**APPLICATION FOR PERMISSION
UNDER SECTION 16 OF
THE TOWN PLANNING ORDINANCE
(CAP. 131)**

For Official Use Only 請勿填寫此欄	Application No. 申請編號	A/71-KTN/1107
	Date Received 收到日期	- 9 APR 2025

Application No. 申請編號	(For Official Use Only) (請勿填寫此欄)		
Location/address 位置／地址	Lots 1058 RP, 1059 RP, 1060 and 1061 in D.D. 107, Fung Kat Heung, Kam Tin, Yuen Long, New Territories		
Site area 地盤面積	912	sq. m 平方米	<input checked="" type="checkbox"/> About 約
	(includes Government land of 包括政府土地	N/A	sq. m 平方米 <input type="checkbox"/> About 約)
Plan 圖則	Approved Kam Tin North OZP No.: S/YL-KTN/11		
Zoning 地帶	"Agriculture" Zone		
Applied use/ development 申請用途／發展	Proposed Temporary Place of Recreation, Sports or Culture (Hobby Farm) with Ancillary Facilities and Associated Filling of Land for a Period of 5 Years

(S.16 Planning Application No. A/YL-KTN/1107)

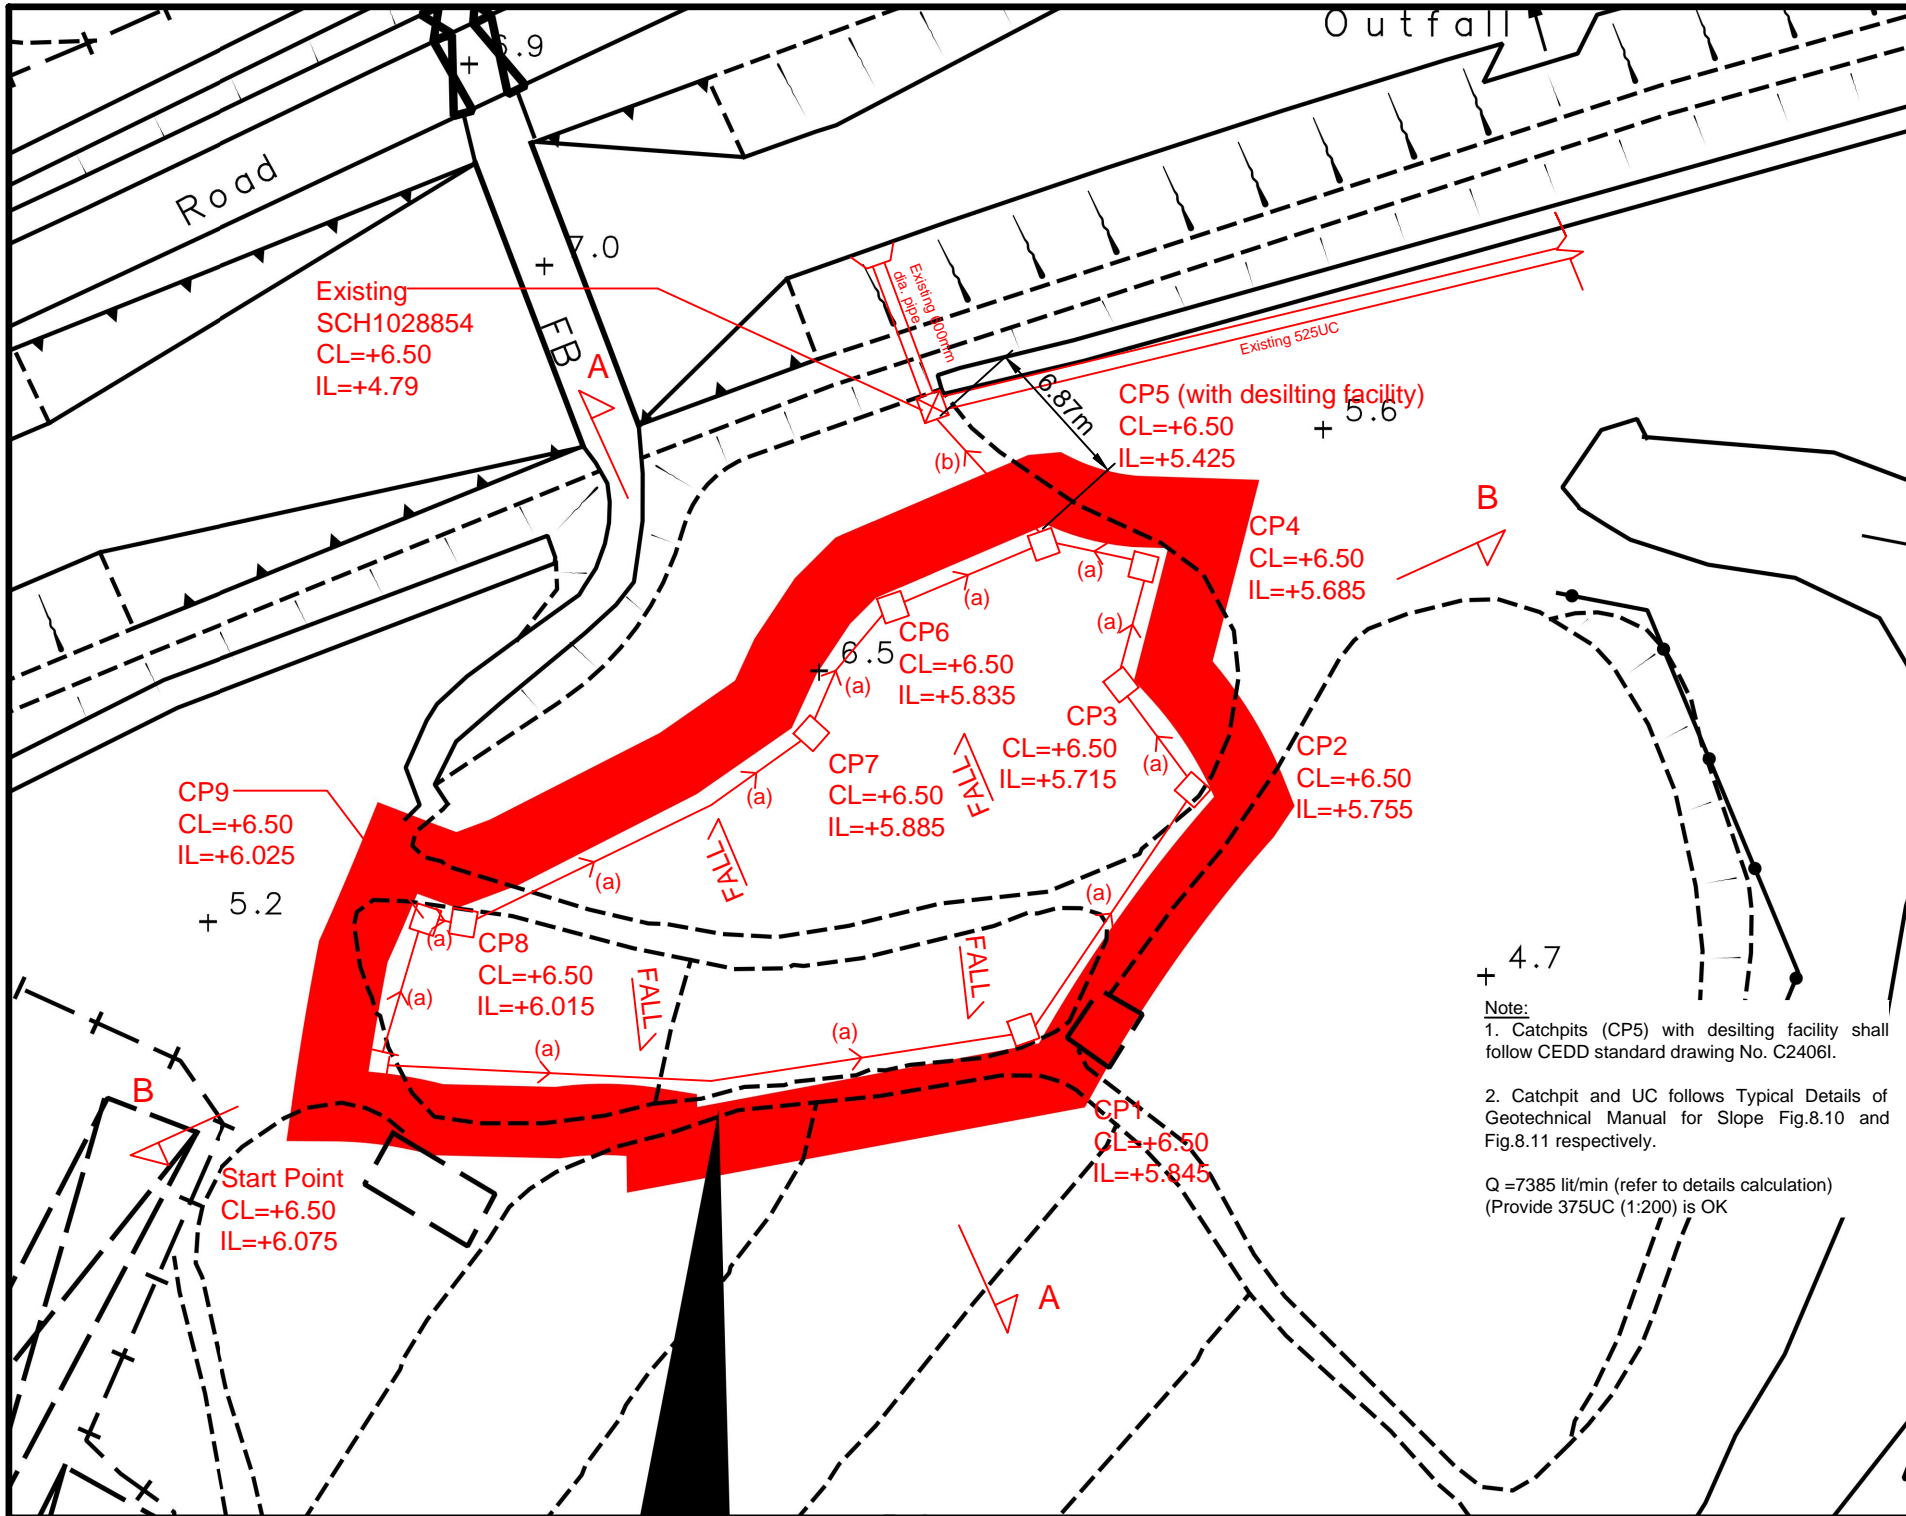
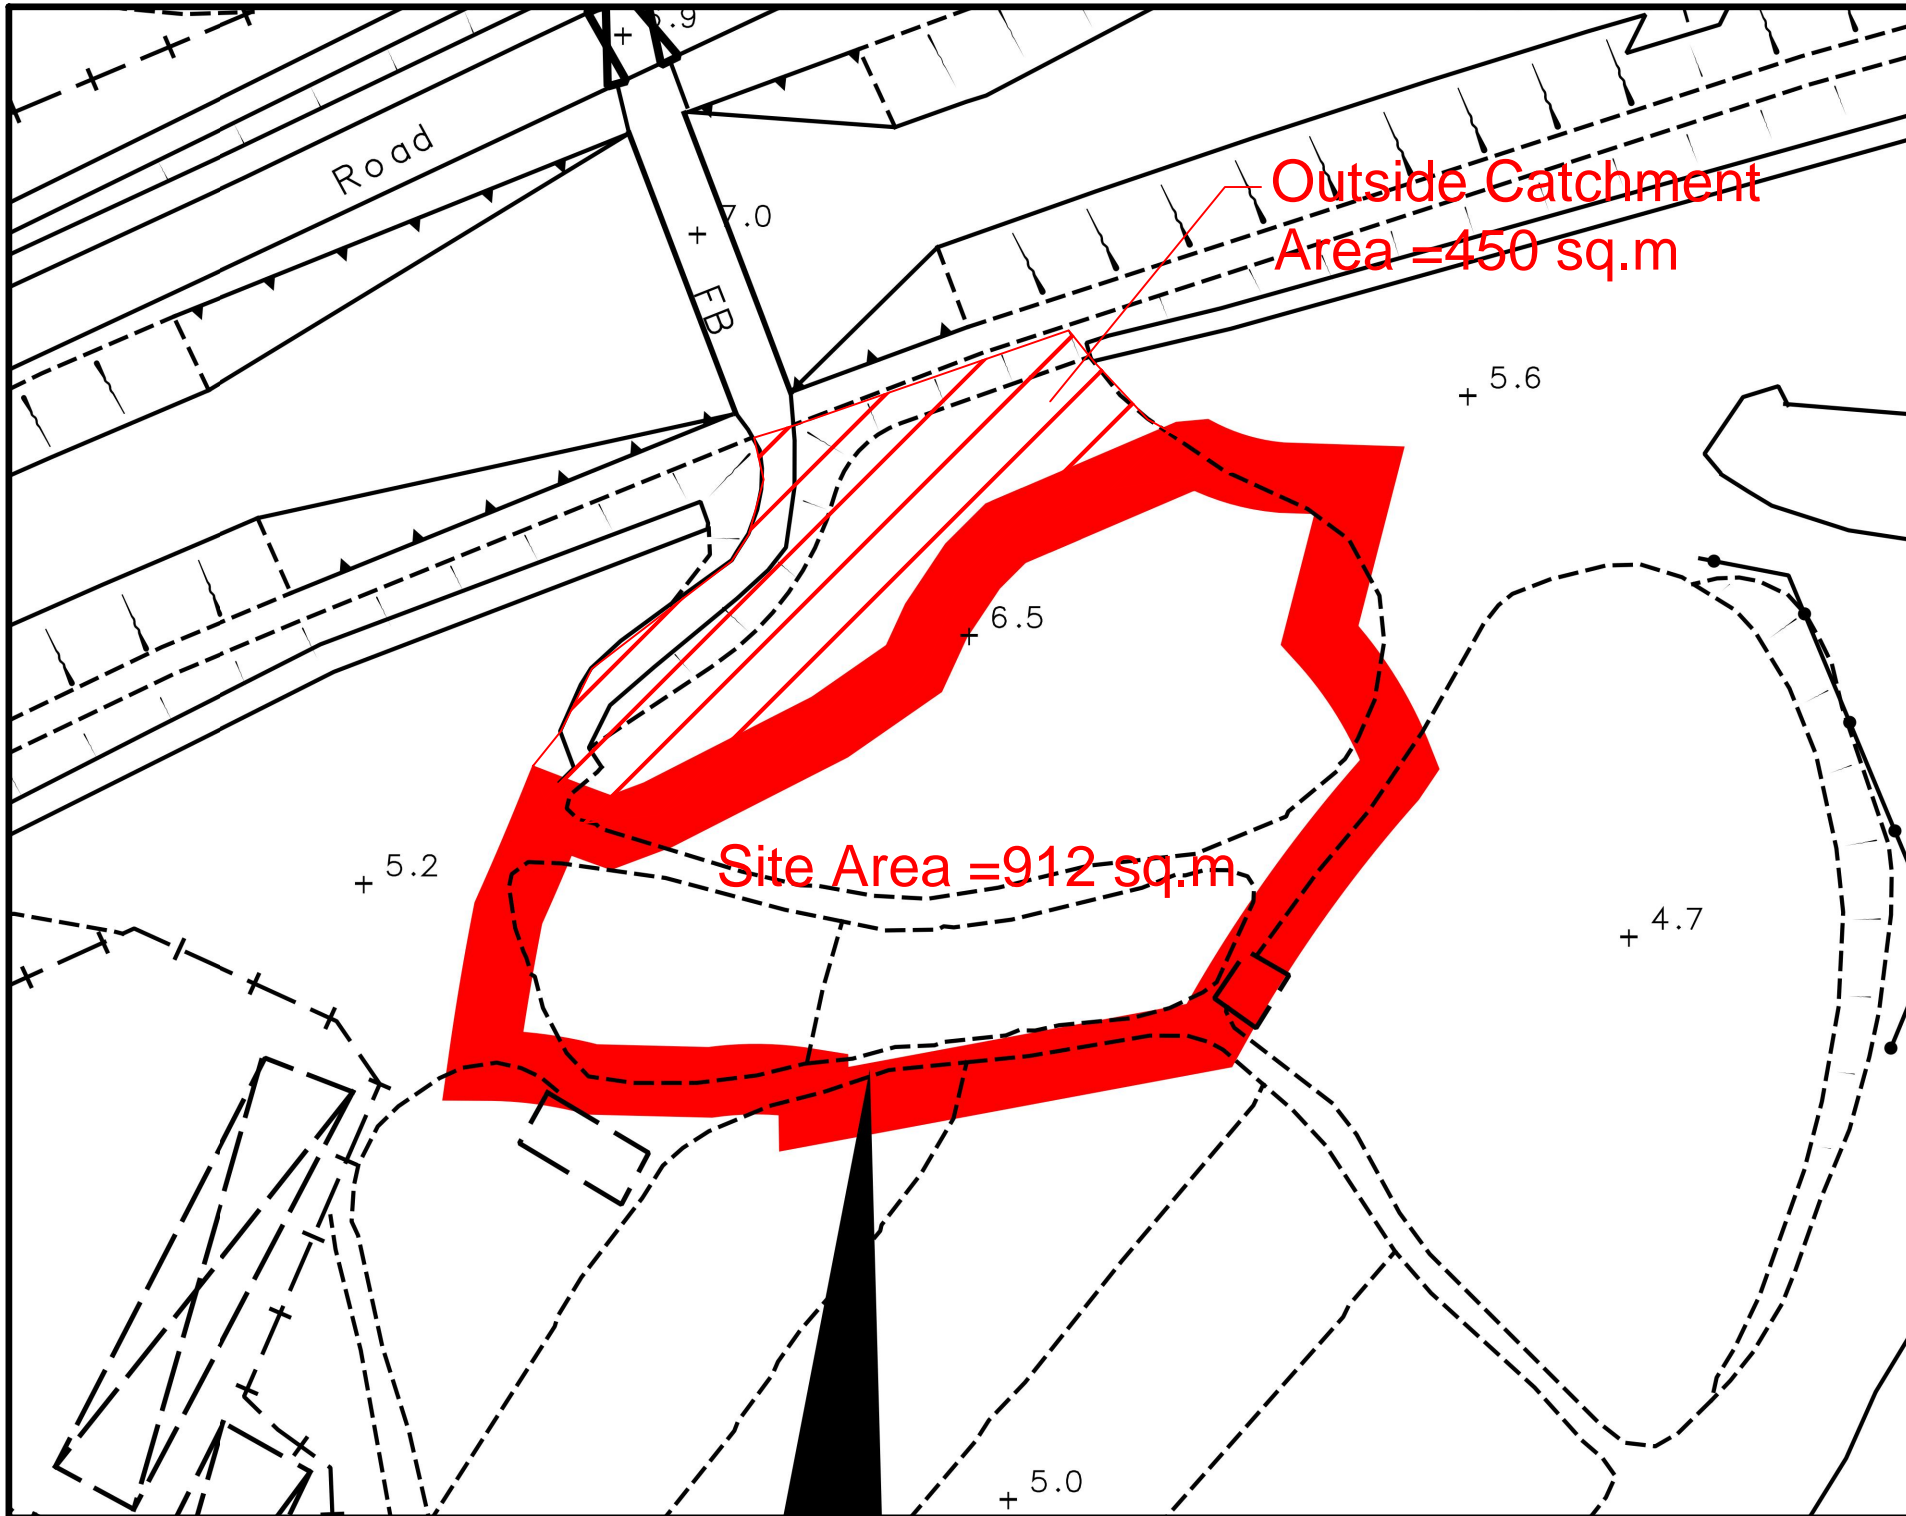
2. Comments of the Chief Engineer/Mainland North, Drainage Services Department (CE/MN, DSD)		
(a)	Please provide connection details for the proposed discharge point at the existing SCH1028854.	Connection details for the proposed discharge at the existing SCH1028854 was presented in drawing D03, the scale is enlarged for easy reference. Please refer to the revised drainage proposal at Annex 2 .

(b)	Please advise and indicate the proposed invert level (from CP5) at the existing SCH1028854.	The proposed invert level (from CP5) at the existing SCH1028854 was presented in drawing D03, the scale is enlarged for easy reference.

DWG NO.	VER.
PLAN 5	001

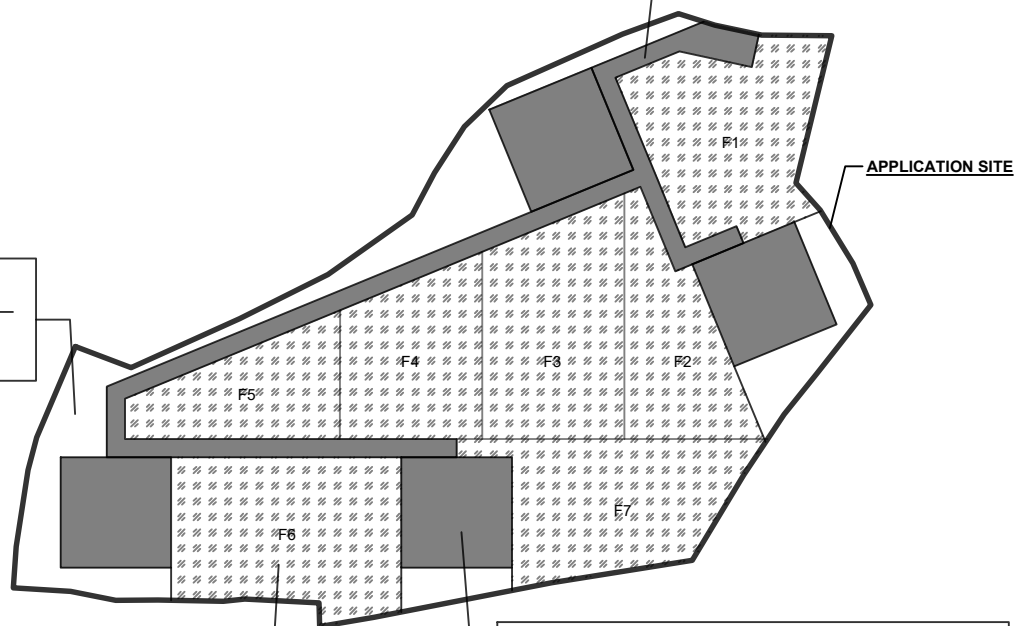
- (i) The applicant provides the following clarifications as per the request of the District Planning Officer/Fanling, Sheung Shui and Yuen Long East, Planning Department (DPO/FSYLE, PlanD):
- the original site level of the application site (the Site) was at 6.5 mPD;
 - during the approval period of the previous planning application No. A/YL-KTN/806, portion the Site (i.e. about 222 m²; about 24% of the Site) has been covered with existing hard-paving of not more than 0.2 m in depth;
 - the current application serves to regularise the existing hard paving, where the existing level of the hard-paving is between 6.6 mPD to 6.7 mPD; and
 - please refer to the revised plan showing the filling of land at the Site.

FILLING OF LAND AREA	
ORIGINAL SITE LEVEL	: +6.5mPD (ABOUT)
PURPOSE	: SITE FORMATION OF STRUCTURE
EXISTING SITE LEVEL	: +6.7mPD (ABOUT)
DEPTH OF LAND FILLING	: NOT MORE THAN 0.2m

FILLING OF LAND AREA	
ORIGINAL SITE LEVEL	: +6.5mPD (ABOUT)
PURPOSE	: CIRCULATION & PARKING SPACES
EXISTING SITE LEVEL	: +6.6mPD (ABOUT)
DEPTH OF LAND FILLING	: NOT MORE THAN 0.1m

DWG. NO.
PLAN 1

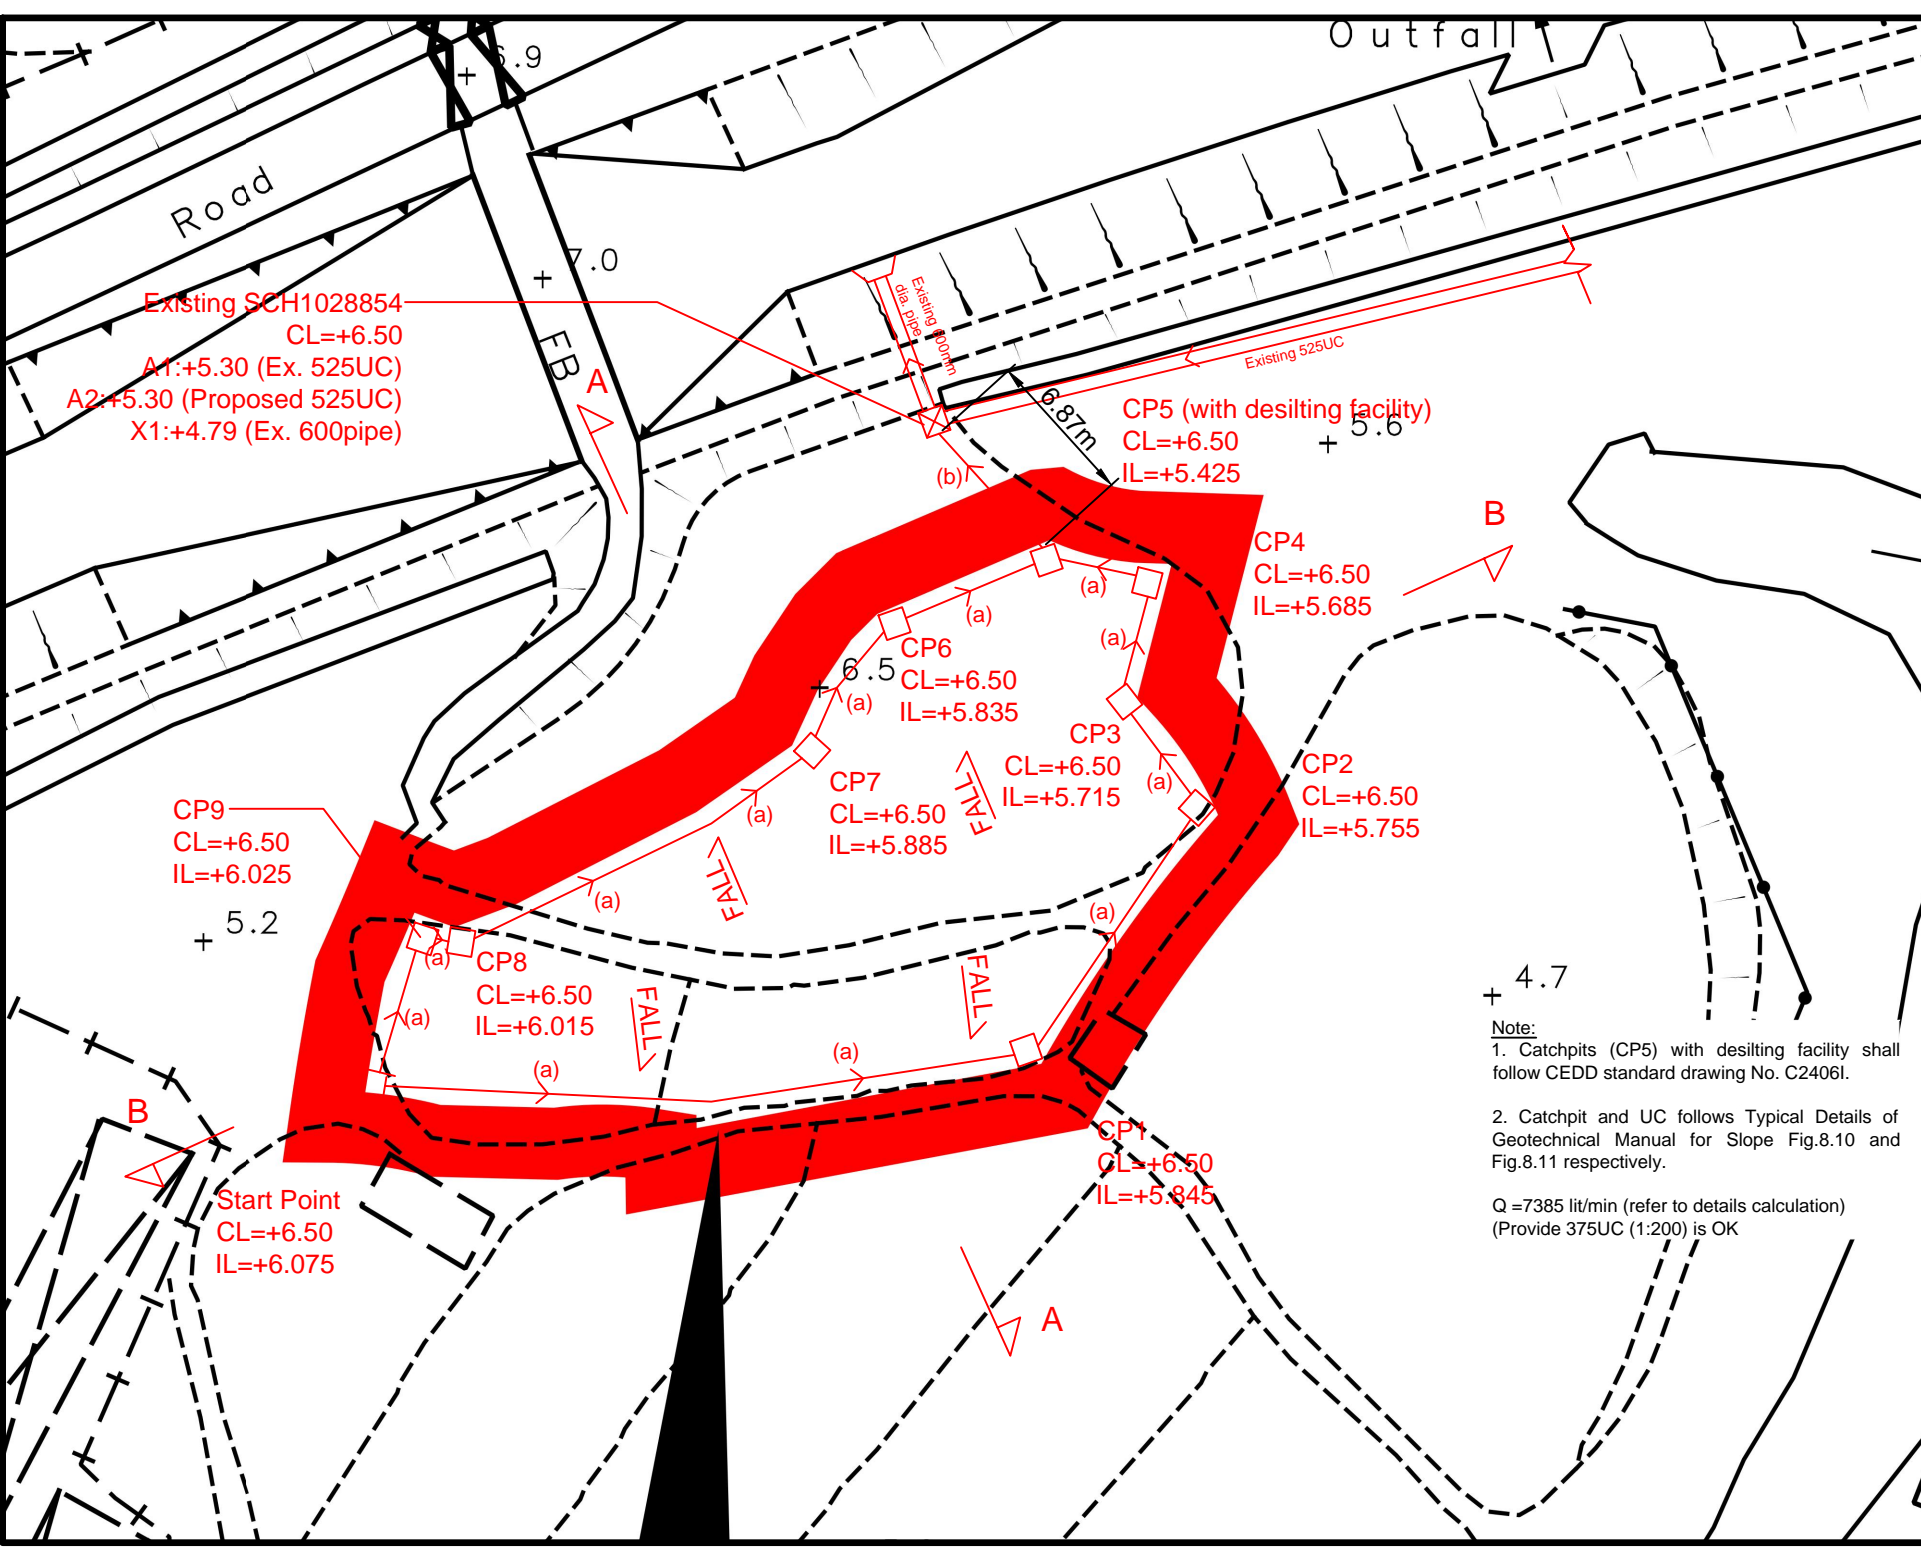
- a revised drainage proposal; and
- a location plan showing a revised access.
